Access Compliance Report

Public Rights-of-Way

Intersection ID: 28364	Main Street: HIGHLANDS_CROSSING_DR	Cross Street: SOUTHAMPTON_COMMONS_DR	Location: NW
ADA ID: 0E08C37131E0	Ramp Type: PerpDiag	Initial Pass/Fail: Fail	Overall Compliance: No
Severity Score: 21.25			
Codes/Mitigation Info/Possible Solution		Field Measurements/Component Compliance

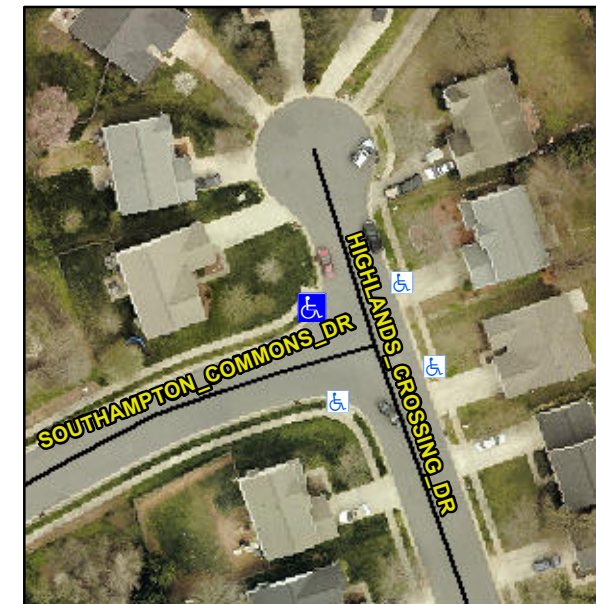
Not Found, R304.5.1, R304.5.3

Compliance	Description	Data	Compliance	Description	Data
N/A	Ramp Length (in)	47.0	Yes	Ramp Slope (%)	8.2
No	Ramp Width (in)	38.0	No	Ramp XSlope (%)	5.3
N/A	Flare Type LT	N/A	N/A	Flare Type RT	N/A
N/A	Flare Slope LT (%)	N/A	N/A	Flare Slope RT (%)	N/A
N/A	Flare Traversable LT?	N/A	N/A	Flare Traversable RT?	N/A
N/A	Landing Length (in)	N/A	N/A	DWS Provided?	N/A
N/A	Landing Width (in)	N/A	N/A	DWS Contrast?	N/A
N/A	Landing Slope (%)	N/A	N/A	DWS Length (in)	N/A
N/A	Landing X Slope (%)	N/A	N/A	DWS Full Width?	N/A
N/A	Landing Curb? (Y/N)	N/A	N/A	DWS Offset (in)	N/A
N/A	Shared Landing?	N/A			
N/A	Gutter Ponding?	N/A	N/A	Gutter Slope (%)	N/A
N/A	Gutter Lip Ht (in)	N/A	N/A	Gutter X Slope (%)	N/A
N/A	Painted X Walk1?	No	N/A	Painted X Walk2?	No
	X Walk 1 Direction	To S		X Walk 2 Direction	To E
N/A	X Walk 1 Width (in)	N/A	N/A	X Walk 2 Width (in)	N/A
	X Walk 1 Slope (%)	3.9		X Walk 2 Slope (%)	2.8
	X Walk 1 X Slope (%)	2.9		X Walk 2 X Slope (%)	2.6

Remove & Replace Curb Ramp With Two New Directional Ramps or Equivalent.
